RE: Response to Second Request for Additional Information
Central County Solid Waste Disposal Complex, Sarasota County
Phase I Partial Closure
Pending Permit No.: 130542-014-SF/01
WACS No.: SWD/58/51614

On behalf of Sarasota County Solid Waste Management Department, HDR Engineering, Inc. (HDR) is pleased to provide the following information in response to the Florida Department of Environmental Protection's (FDEP) August 12, 2010 Second Request for Additional Information (RAI #2) regarding the Central County Solid Waste Disposal Complex Class I Landfill Phase I Partial Closure Permit Application.

Figure 1609
STATE OF FLORIDA
WIND-BORNE DEBRIS REGION & BASIC WIND SPEED

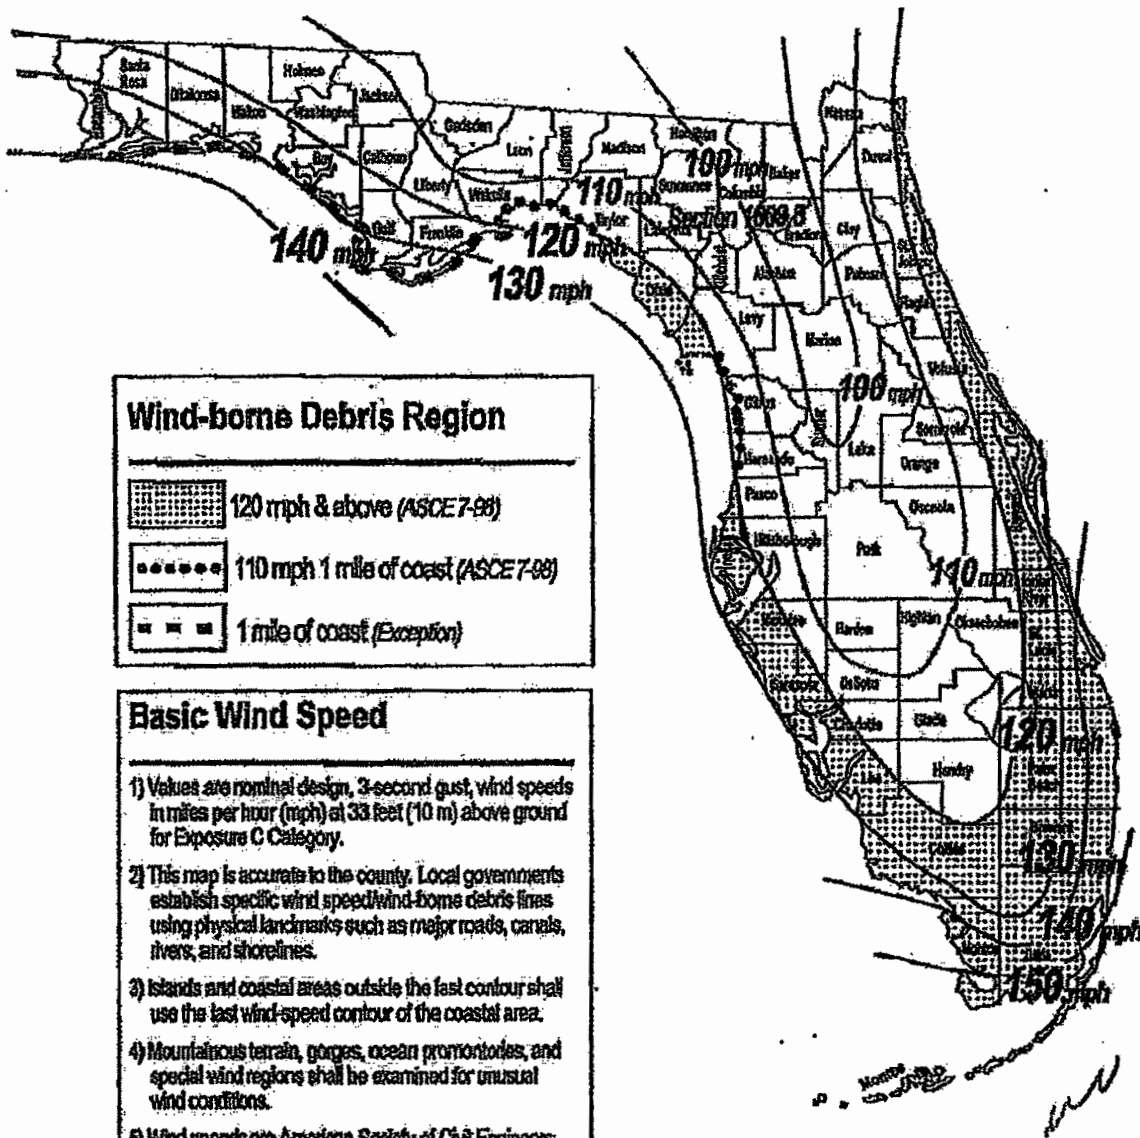
b. The calculated factors of safety for against uplift range from 1.16 to 1.37. Unless supporting justification is provided, a minimum factor of safety of 1.5 for final cover anchor trench design is typically provided for landfill closure projects. Please provide supporting information and/or references for the accepted uplift factors of safety for this project.

Response 2.b.: The exposed geomembrane cover (EGC) design is based on 130 mph basic wind speed determined from the Florida Building Code for Sarasota County. This is the velocity recommended by the building code to develop wind loads for design of buildings, structures and parts thereof.

Use 130 mph
for Sarasota
County.

00C-05

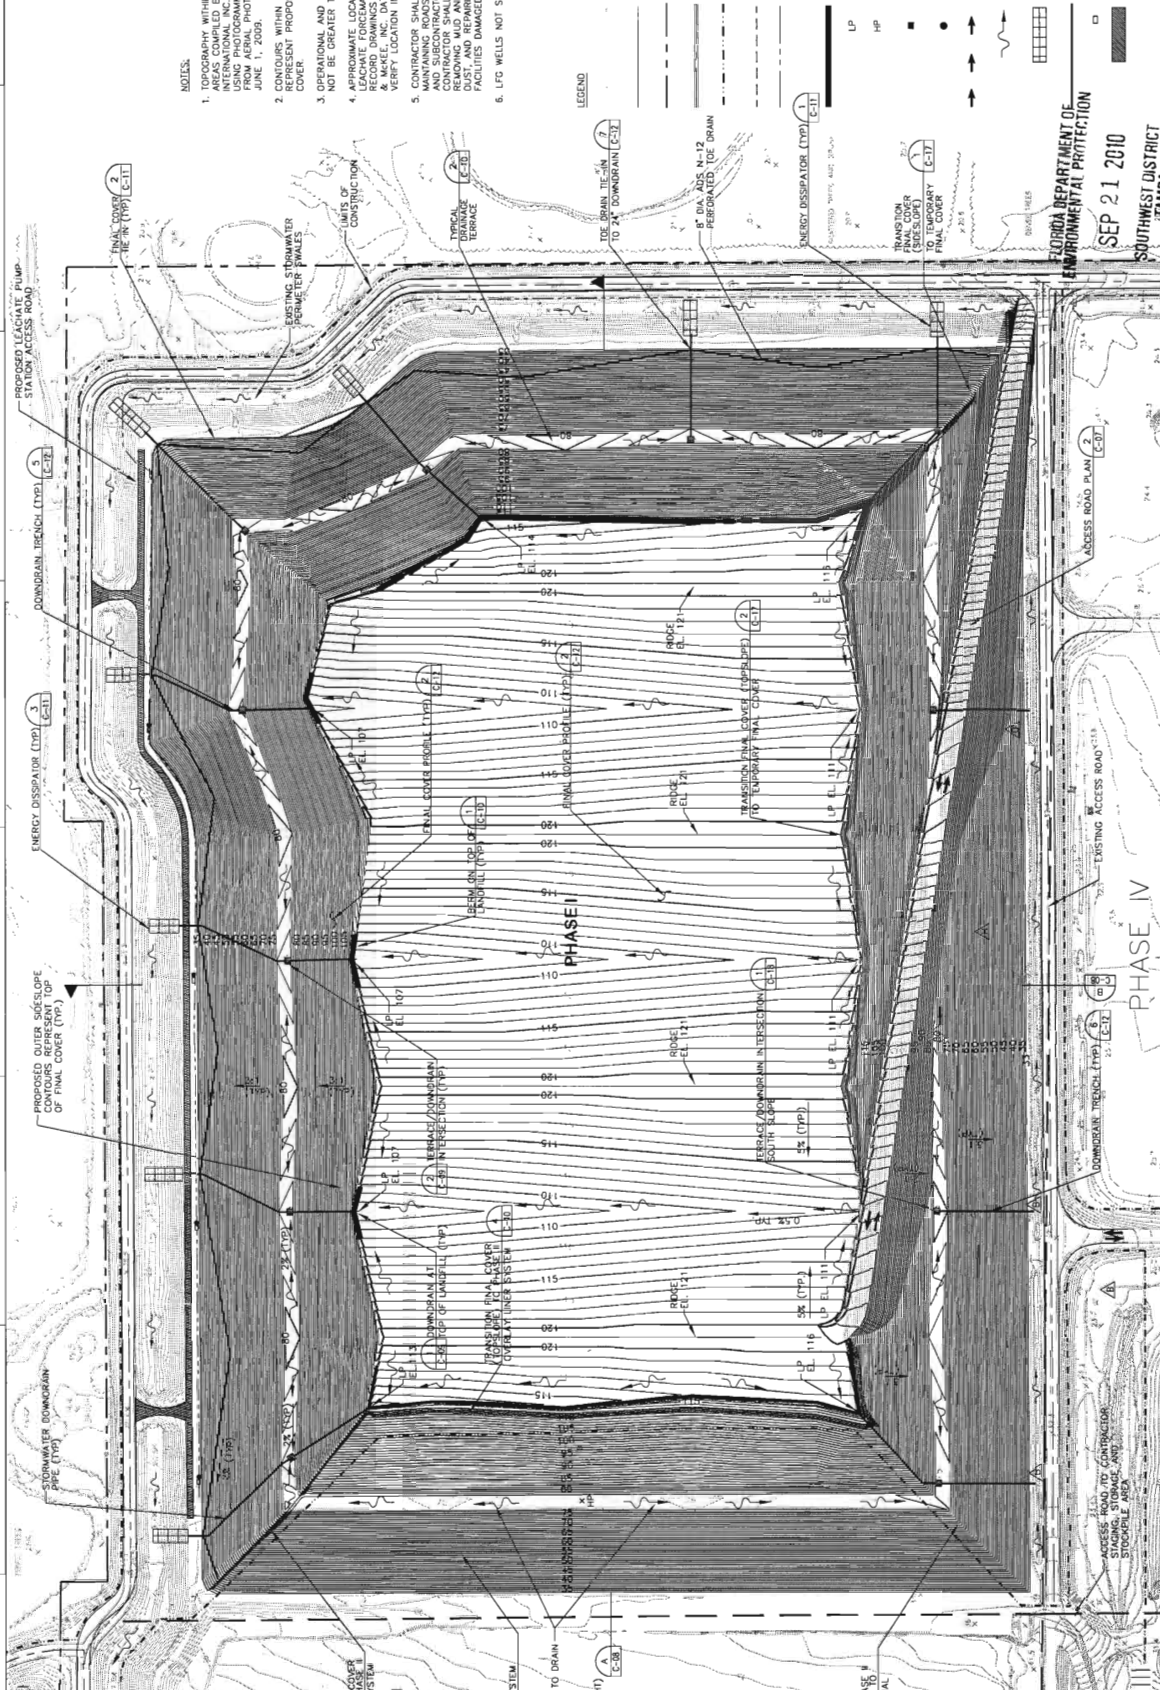
- **Sheet C-05 – The locations of the stormwater drains from the mid-slope terrace have been adjusted to account for the locations of the leachate collection pump stations (LCP) located on the north toe of the Phase I Closure. The stormwater pipe will be angled from the terrace to provide sufficient setback from the LCPs. This results in a slight reduction in slope of the downdrains from 33% (3H:1V) to a minimum of 22%. Therefore, the flow rate available in the 24-inch downdrain pipes is reduced from 112 cfs to 92 cfs which remains sufficiently greater than the required flow rate of 12.4 cfs for the 25-year 24-hour design storm. With the reduced slope, the downdrains maintain sufficient flow capacity for the design storm.**

TPO PHOTOS

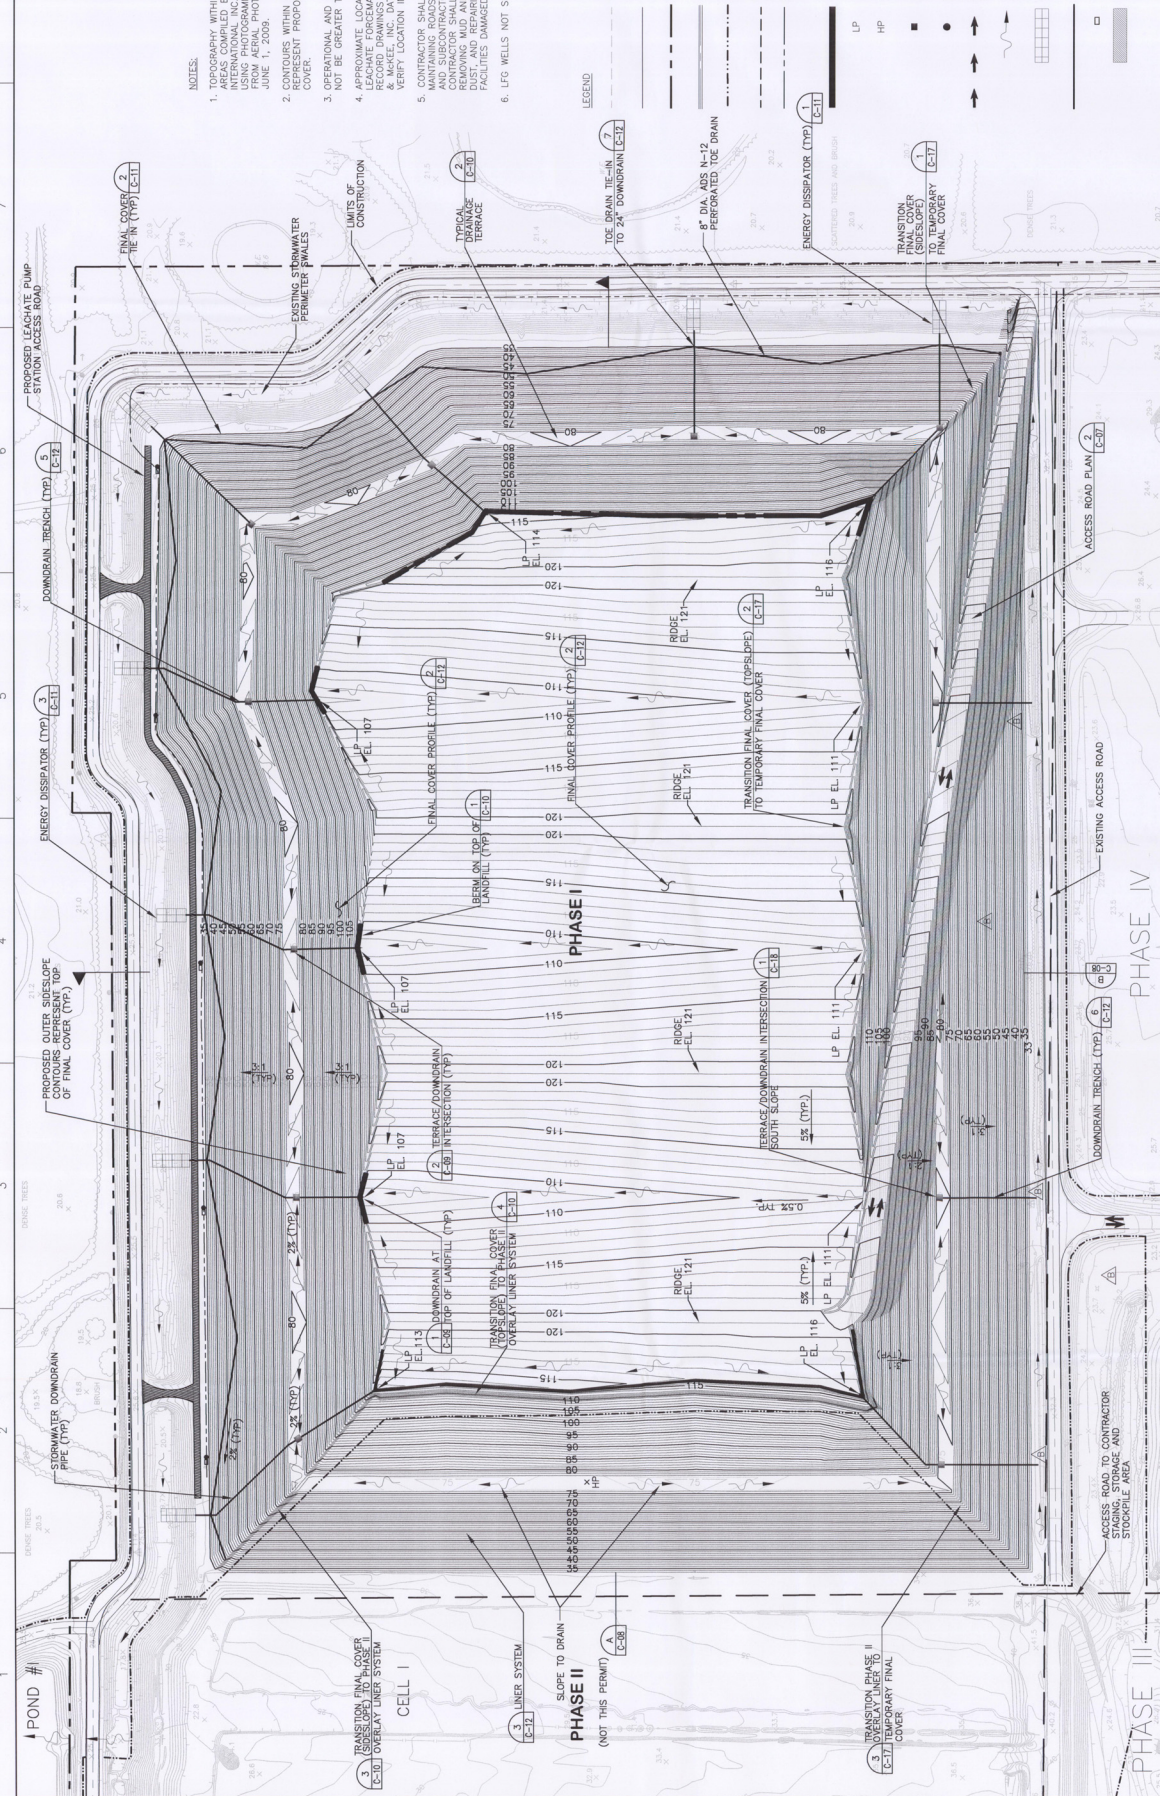
Comment 4. §2.6.6: Based on the smoothness of TPO material to be utilized on this project, it appears that it would be difficult for landfill personnel to access (i.e. walk on) the TPO side slope to conduct the inspections described in this section. Please explain how inspection will be conducted.

Response 4: The TPO material provides a rubbery tackiness which allows personnel to walk on the material on a slope. Please refer to the photos provided in Attachment D for examples of access on the TPO surface by inspection and construction personnel at a project site in Texas.

00C-04

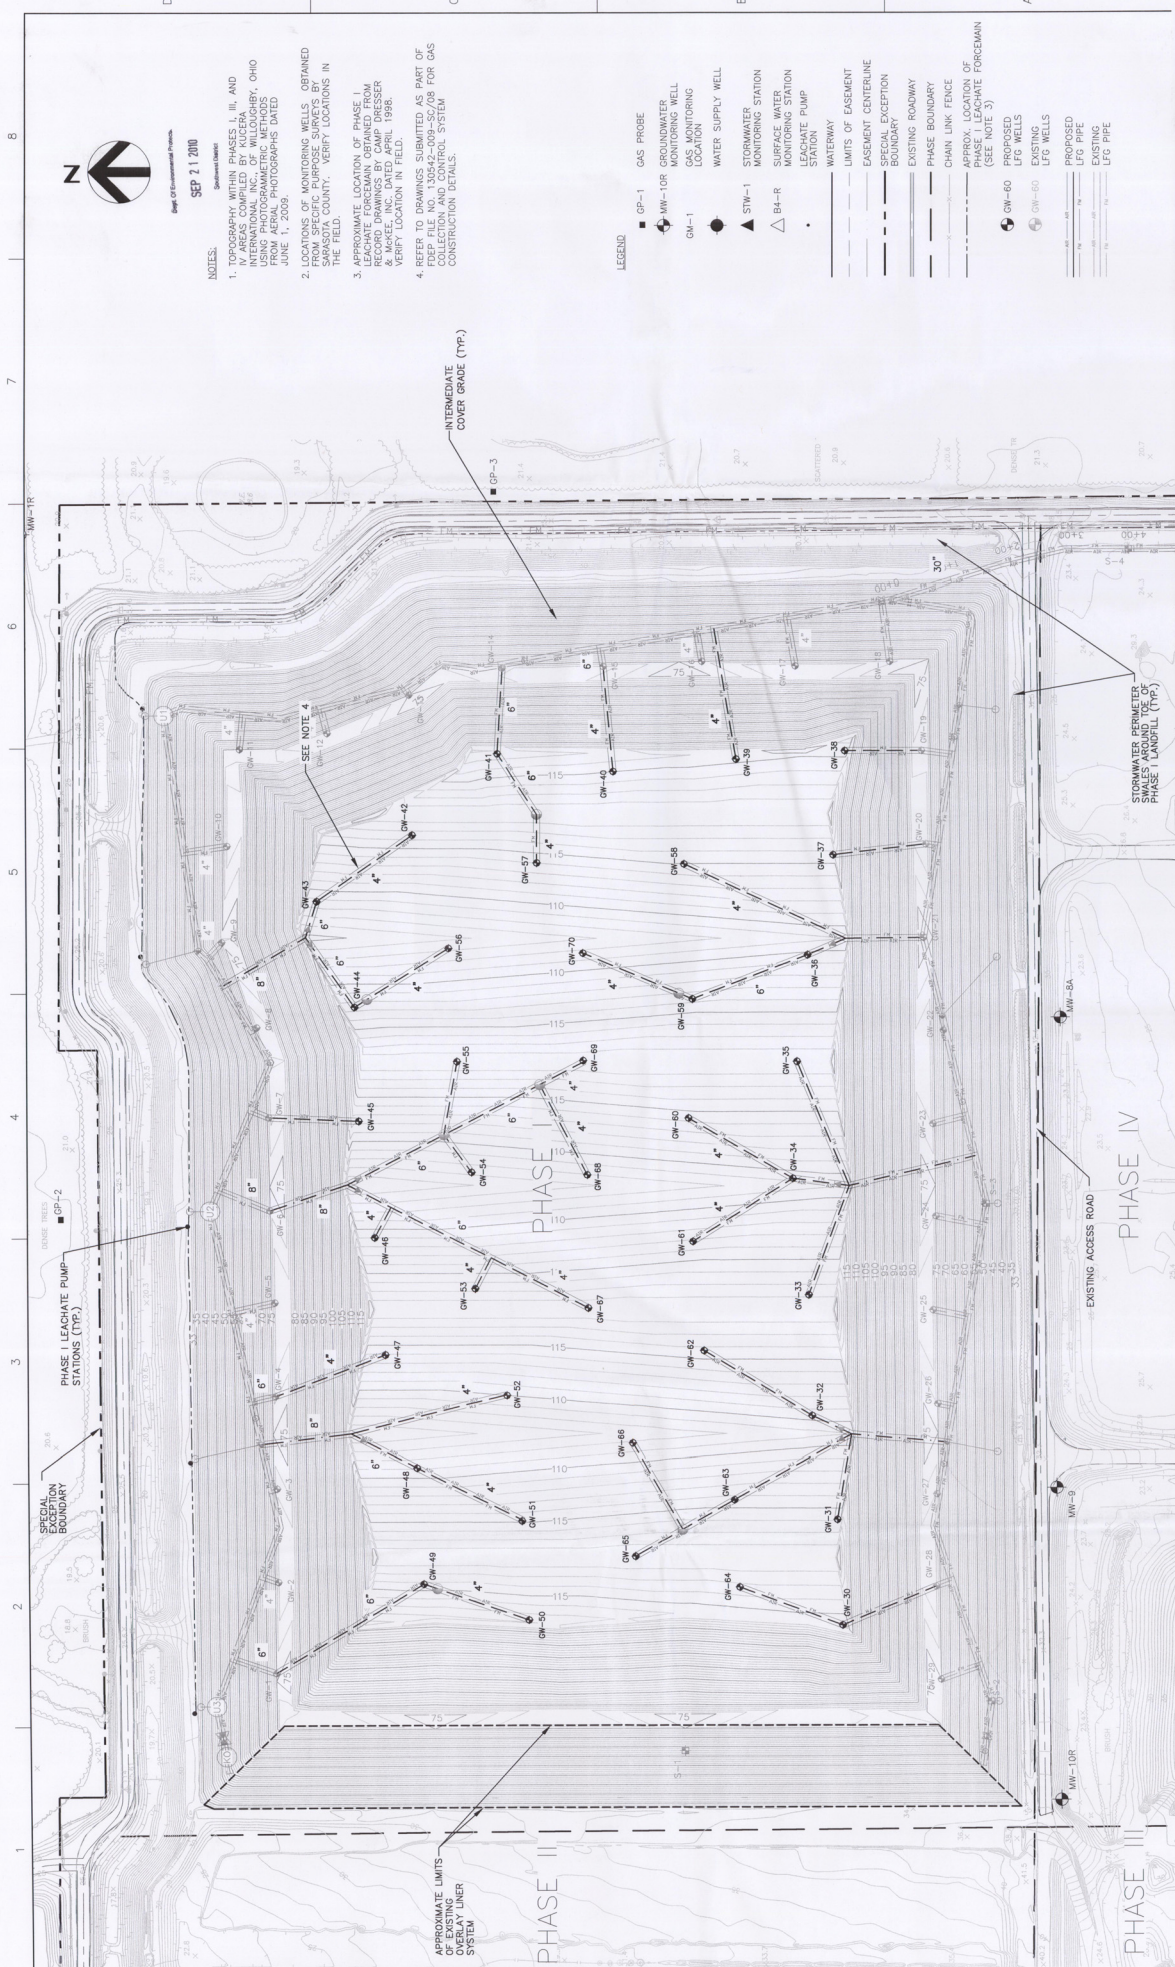
- **Sheet C-04 – This sheet has been revised to reflect the intermediate cover contours for the project. These contours represent a 2-foot difference from the contours provided on Sheet C-05 which represent the final cover contours.**

**PHASE I TEMPORARY FINAL COVER
ANCHOR TRENCH SECTIONS AND DETAILS**

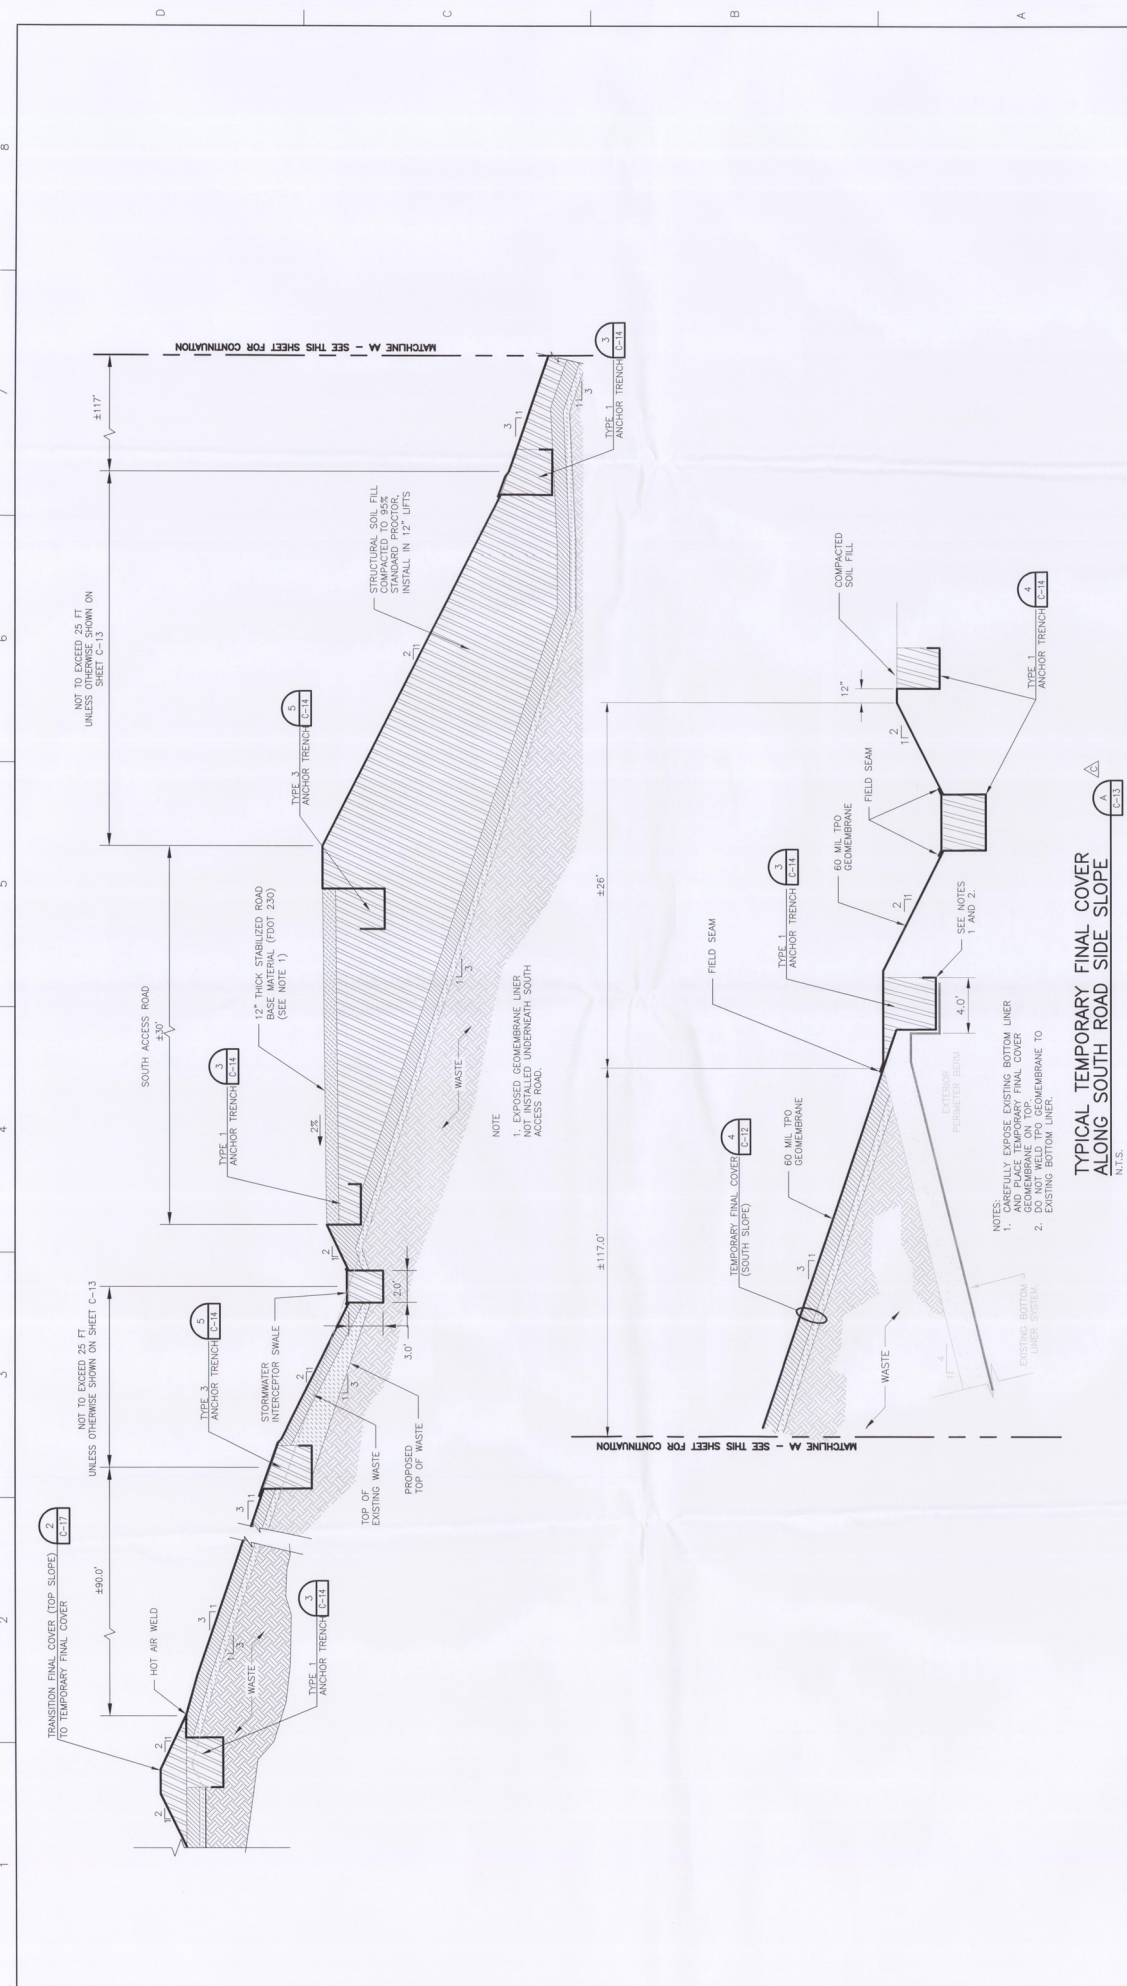
*Comment 3. **Sheets C-016:** The plan view on Sheet C-013 and Section A on Sheet C-016 show a proposed 2H:1V side slope above the side access road. Rule 62-701.500(7)(c), F.A.C. and Rule 62-701.600(3)(e), F.A.C. respectively specify that above-grade operation and closure side slopes shall not be steeper than 3H:1V. Please verify and revise the temporary closure design shown on these sheets accordingly.*

Response 3: The 2H:1V side slope above the side access road must be constructed to provide the stormwater swale above the access road. The 2H:1V slope is only in very limited areas of the landfill above the access road. The waste will be constructed at a 3H:1V slope in accordance with the filling plan, however, during construction of the closure and access road, the waste in these areas will be cut out and replaced with soil at 2H:1V. The revised Sheet C-16 which clarifies the conditions at the access road along the south slope is provided in Attachment C. A line representing the existing top of

waste is also provided to show areas of excavated waste that will be required to construct the access road.
